Climate Adaptation Scilly  
Porthmellon Enterprise Centre  
St Mary's  
Isles of Scilly TR21 0LW

**Our ref:** CAS-EA1  
**Your ref:** P/22/077/FUL

**APPLICATION FOR THE INSTALLATION OF GEOBAGS AT PERIGLIS TO REPLACE THE CORE OF EXISTING DUNES, WRAPPED IN GEOTEXTILE AND COVERED WITH EXCAVATED MATERIAL AND TO STABILISE THE DUNE CREST WITH GEOMAT TO ENCOURAGE RE-VEGETATION. INSTALLATION OF ROCK BAGS AT PORTH COOSE TO HEIGHTEN THE EXISTING PROTECTION, BACKED BY EARTH BUND AND INSTALLING ROCK ARMOUR AT THE BOTTOM OF THE EXISTING SEA WALL AT PORTH KILLIER. TO REDUCE THE RISK OF COASTAL FLOODING ON ST AGNES. (EIA DEVELOPMENT) (MAJOR DEVELOPMENT) LAND ADJ TO WASTE SITE, THE QUAY, ST AGNES, ISLES OF SCILLY**

Subject: EA Objection to scheme at Port Coose and need for design changes

**Figure 1:** Actual changes in cross-sectional area at Periglis beach, from autumn 2007 to autumn 2020. Positive percentages would indicate accretion, while negative percentages would indicate erosion. All cross sections at Periglis show no change or up to 4% accretion over this period (PCO 2020).

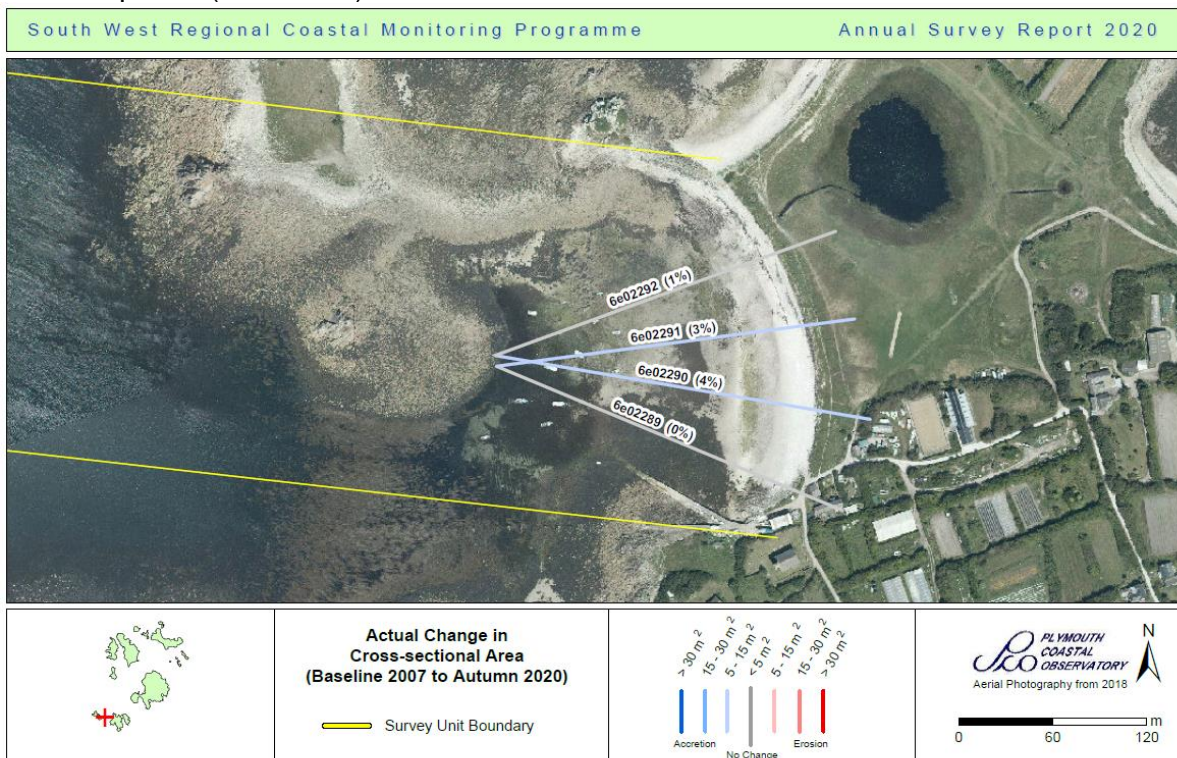
The EA suggest that the coast protection works will be “prone to undermining and failure in the future” because the “dune ridge appears to be in a long-term erosional trend”. Although the EA rely on the Environmental Statement (ES) for this information, the ES is inaccurate.

The independent Plymouth Coastal Observatory annual surveys for this beach from 2007 to 2020 shows that the trend for Periglis is actually accretional (Figure 1). These data include observations both before the 2014 storm and after the 2014 storm.

Despite this actual positive trend to accretion at Periglis over this period, Council proposes to move the geobags further back within the dune in response to the objection. Shifting the geobags rearward will increase the volume of material excavated. In the northern part of the dune, this is likely to remove the dune entirely before reconstruction is undertaken. Council proposes to move the bags back 3 m laterally compared to the originally submitted designs towards the back of the dunes, to minimise the volume of additional material to be excavated and associated increased costs.

**Figure 2:** Final map of seagrass distribution for the Isles of Scilly, from Natural England (2011), page 25.

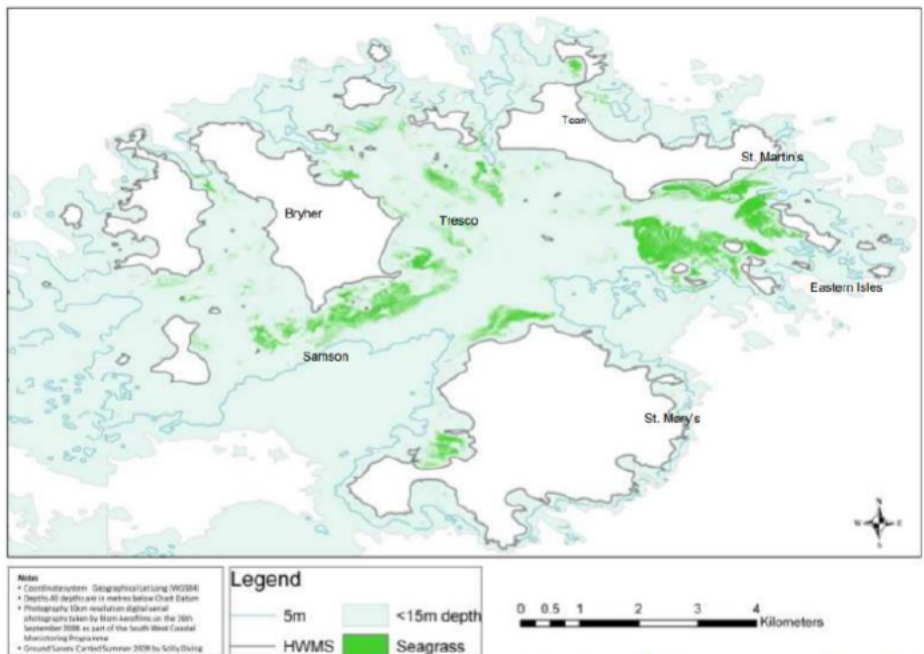
*The Isles of Scilly are covered by SAC and MCZ designations and include interest features such as Zostera (sea-grass) which are known to be sensitive to siltation i.e. suspended solids in the water column can settle out and smother sea-grass.*

Seagrass beds around the Isles of Scilly were mapped by Natural England (2011). Figure 12 of that study (included as Figure 2 here, note island name labels are misplaced in the original figure) identified where seagrass was likely to be found around the islands. No seagrass is expected to be present near works on St Agnes, nor Bryher (except Kitchen Porth). No seagrass present near the works on St Martin's is likely to be affected since all these works occur on land or above MHWS.

Figure 1: Site 50 – Typical section

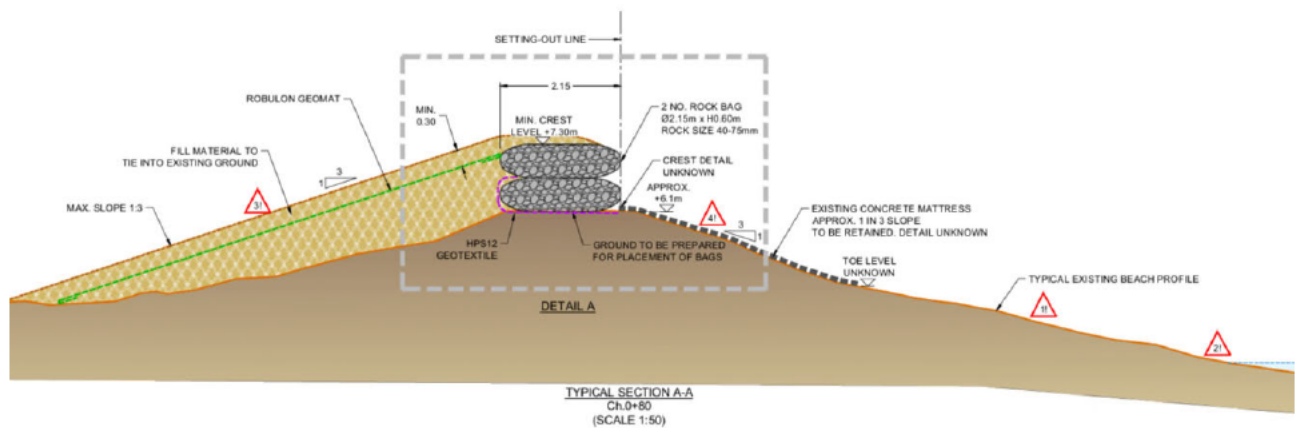
*We have further concerns with regard to the design of the Porth Coose coast protection works. Currently, the Armourflex concrete mattress is covered by shingle, although this was partially exposed in the 2014 storms. The proposed rock bag wall, some 1.2m high, along the crest of the dune will impact wave energy by preventing regular overwash and introducing a hard reflective structure within the wave impact zone. Not only is this liable to lead to increased exposure of the concrete mattress, but also has the potential to damage the structure. Should the concrete mattress be damaged, subside or fail, then the rock bag coast protection wall will be prone to undermining and failure itself.*

*On review of this information, the rock bag design may need to be amended to provide sufficient resilience over the design life. This might include, setting the base of the rock bags below the level of the concrete mattress, designing a sloping face to reduce wave energy reflection, and redesigning the toe protection provided by the concrete mattress.”*

Over the full extent of the beach the Armourflex concrete mattress slope will be retained, as a walk over survey indicated that it is in reasonable condition, and to enhance protection against overtopping, the crest level will be increased through the placement of rock bags with the rear filled, which aim to provide protection from overtopping. The bags will be placed on a prepared surface at the top of the armourflex concrete mattress slope, which will provide protection of the crest of the ridge which is currently eroded at some locations. Fill material is to be placed behind to tie in the top of the bags to the ground behind and to strengthening the ridge where damaged by erosion. A geomat will be placed to stabilise this slope and encourage establishment of vegetation. Sand fill will also be placed on top of the bags to cover and encourage plant colonisation. The general arrangement of the works are shown in drawing DKR6499/D110/111, and the typical cross section for the proposed works is shown in drawing DKR6499/D110/320, Figure 1 below shows an example of a typical section.

The standard of protection to be provided by this option is 1 in 150 years, with a design life of 25 years.

Figure 2 Present schematic representation of the movement of cobbles during storms

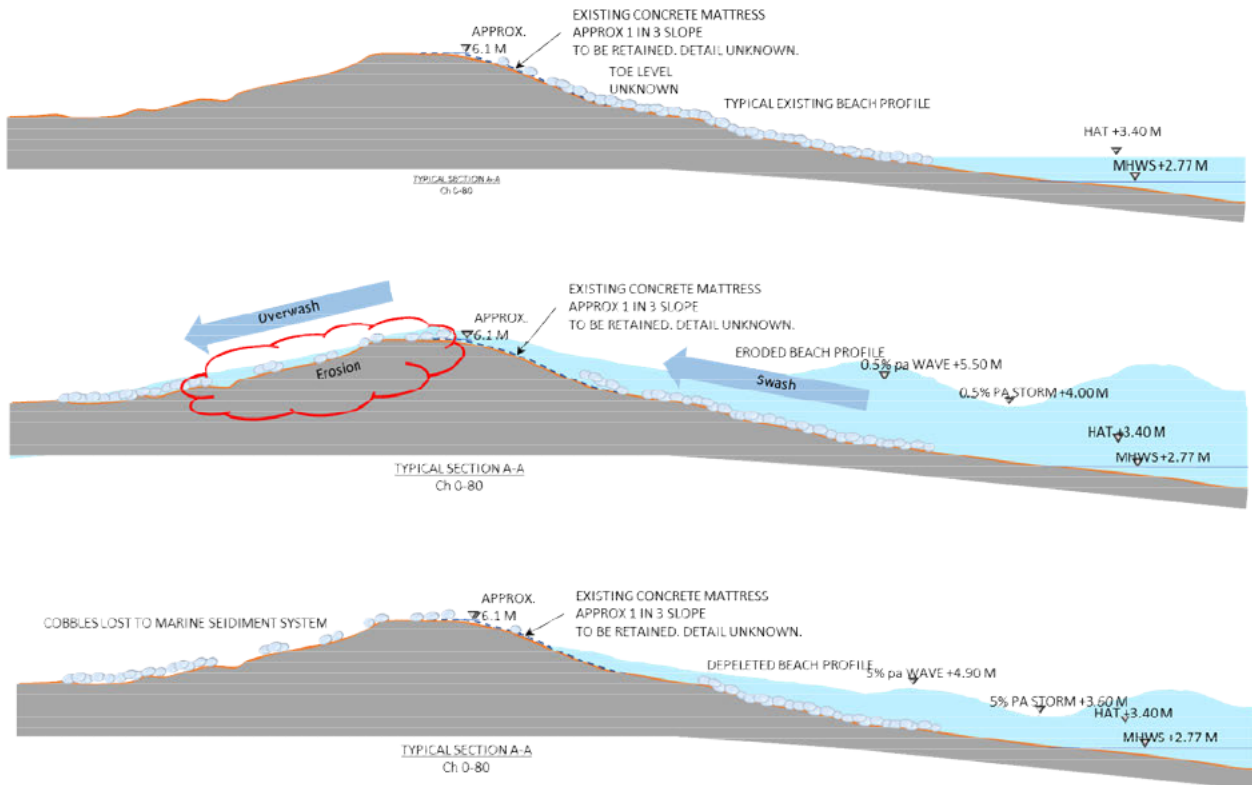
It is acknowledged that run down during severe storms will be likely greater than at present, given that overtopping and overwashing is reduced by the increased crest level, though how much greater can not be estimated with accuracy, unless a physical model test is carried out. The rock bags will provide some level of permeability, therefore absorbing some of the energy, and therefore the option should not be compared to a situation such as a seawall backing a gravel beach.

There is no evidence that would suggest that the presence of the bags can create an offshore movement of cobbles, capable of leaving the system. It is more likely that the cobbles will be moved across and along the shore during a storm, and then will be moving back to the upper beach/toe of the ridge during calmer sea conditions, see Figures 2 and 3 below.

Embankment reinforced with concrete mattresses are not generally designed to be overwashed, though some overtopping may be tolerated. Overwashing would lead to the erosion of the crest and the rear side and then failure, as also shown in Figure 2, and as it is currently happening along some sections. The protection from overwashing, the repairs and the further protection of the rear slope will improve the overall stability and extend the life of the protected ridge to meet the 25 years design requirement.
